First Floor Structure Indicating Second Floor Structure Over

Project:	Fraser House	Eng:	MWS
Title:	First floor structure	Date:	May'23
No:	LM21346-DYSE-XX-ZZ-SK-S-0023	Rev:	P03

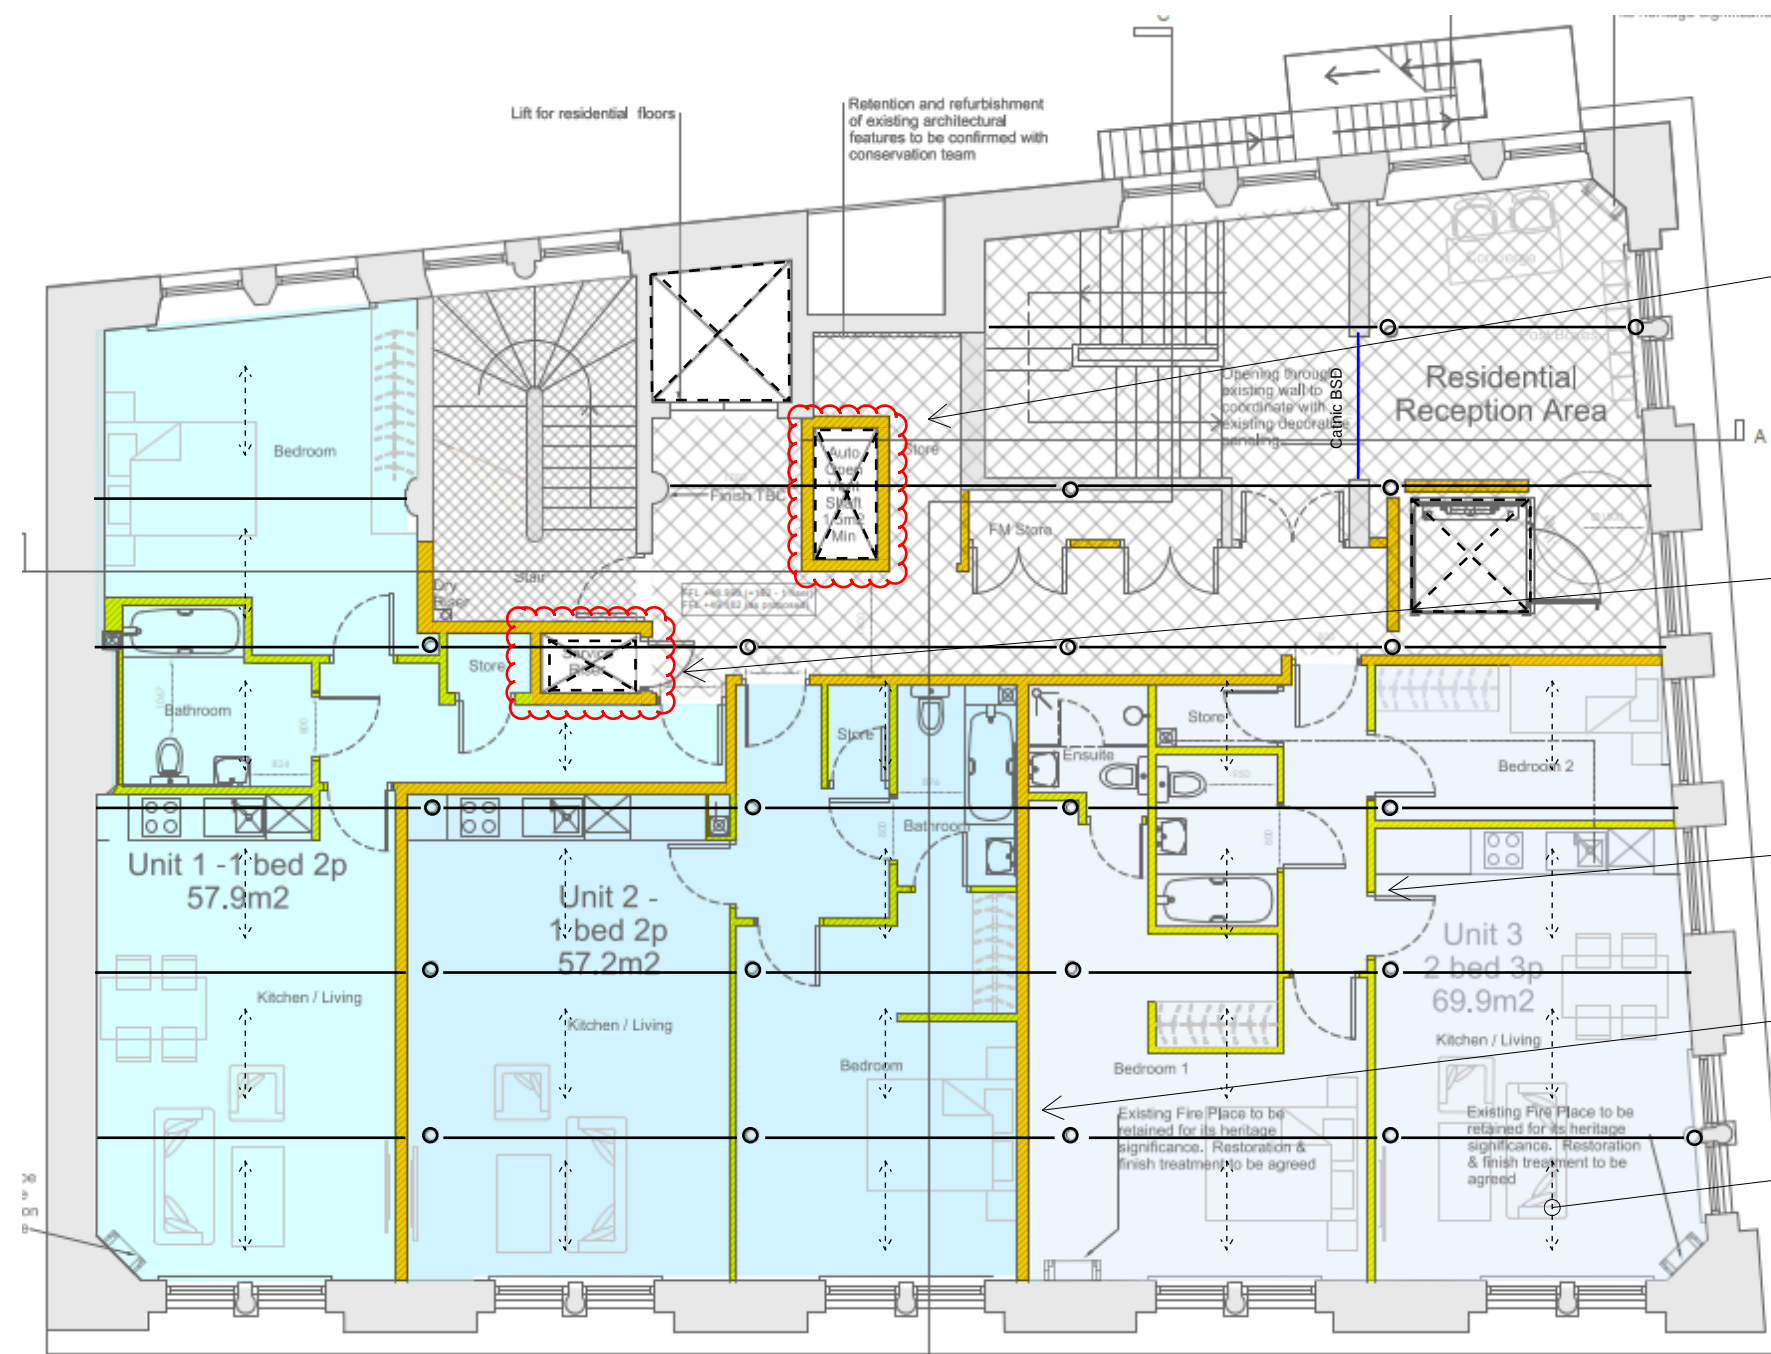
Location of smoke vent cuts through existing primary timber floor beam. Can smoke vent be moved to avoid additional significant structural framing to trim out void for smoke vent. Architects to confirm acceptance.

Location of service riser cuts through existing primary timber floor beam. Can beam continue to pass through service riser to avoid additional significant structural framing to trim out void for smoke vent. Architects & M&E consultants to confirm acceptance.
